Complete Streets Advisory Committee
VIRTUAL Regular Meeting
August 25, 2020 – 4:00 P.M.
AGENDA

Longview Business Park

Public Improvements Phase I

General
Cover Sheet

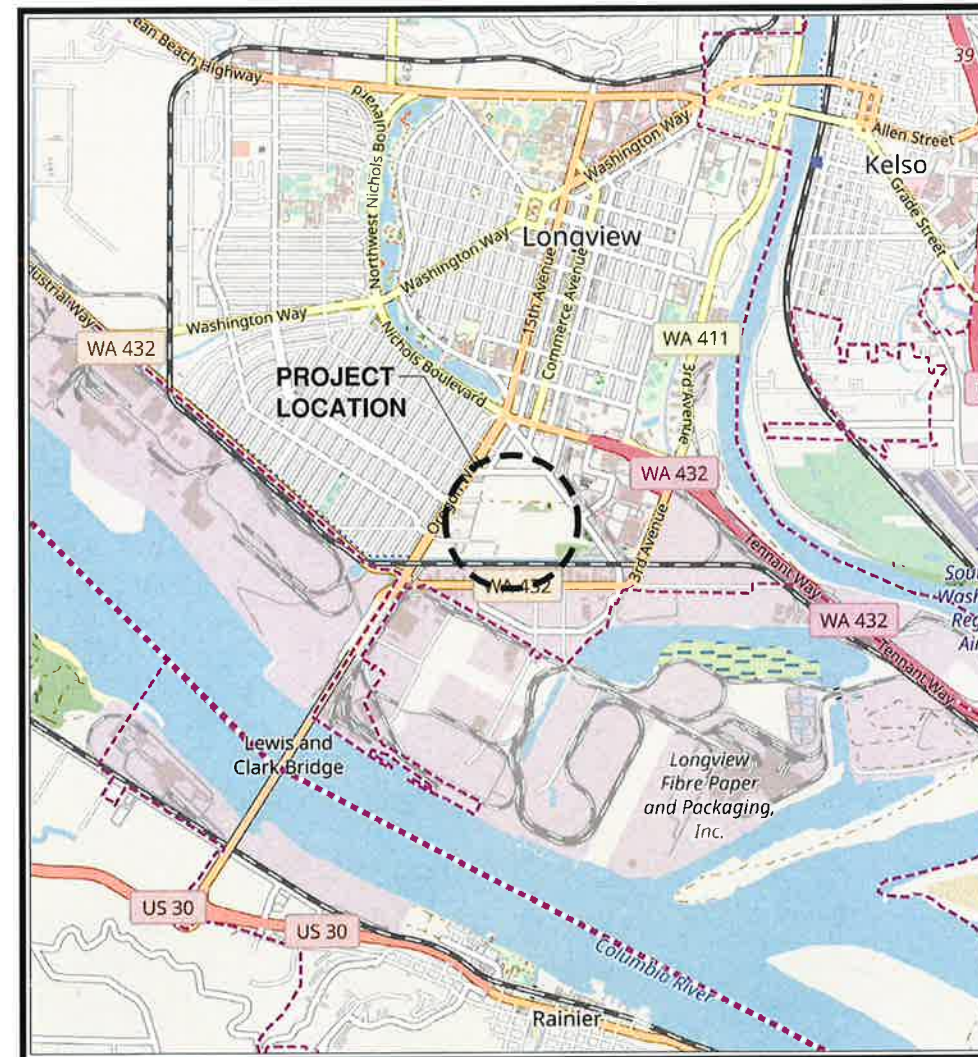
For yours and the Complete Street Advisory Committee consideration. Please note the designation of the roadway is Commercial Access; per LMC 12.50.040. The design speed is only 25-mph. To accompany large trucks; full pavement width will still be 40-ft. I based my cross section and recommendations from other local redeveloped industrial/business parks that have provided multi-discipline road users and on users start and ending designation based on existing locations one may travel and potential future designations within the new development.

After further evaluation of the local street network adjacent to Longview Business Park, the committee should consider that this would be an secondary access road where majority of the users would be using it for direct access to lots and not a thru arterial to other locations. We believe thru bikes/pedestrians will use Beech Street and the end development would either be light industrial with heavy vehicles being the major users or a large box store that would more-likely trigger further SEPA improvements.

I am also recommending a major change and only doing one-half sidewalk improvements in this proposal. Two reasons. First, to allow end development user demand to determine if a shared-path is more appropriate because the Owner still does not know what the specific end-use will be. Second, Owner needs to lower costs of these public improvements and sell some lots to create more capital to make first phase more feasible. Also, if it is a box store that might have more bike/pedestrian users, the proposed roadway section would allow easy re-construction for the right multi-use improvements to the proposed un-improved area in this street section. Lastly, if a development that requires more capacity for demand and future lane widening are needed (for turn lanes), there would also be the benefit to the environment by reducing the impact of relocating the sidewalk potential in the wrong location in the future.

Current roadway channelization (64-ft ROW):

- (2) two 13-ft travel lanes
- 14-ft center two-way-left turn pocket
- (2) two street adjacent 6-ft buffer stripes with street trees
- (2) two 5-ft sidewalks

Proposed roadway channelization after re-evaluating (Still 64-ft ROW):

- (2) two 20-ft travel lanes (one center double lane line or no striping)
- (1) one adjacent 6-ft sidewalk on Northside of Alaska Street and Eastside of 11th Avenue for phase 1
- (1) one 6-ft reserve area on Southside of Alaska Street and Westside of 11th Avenue for site's to develop upon building permit phase.
- (2) two 6-ft buffer strip with street trees on the outside of the proposed sidewalk and reserve areas.

Please see the attached cross section of the proposed roadway channelization for first phase 1 for the City's and Advisory Committee's consideration.

However, if you like to leave the sidewalk/buffer stripe as originally designed in second attachment, we would still like to recommend a center stripe for now (no TWLTL) and request to do one side sidewalk improvements.
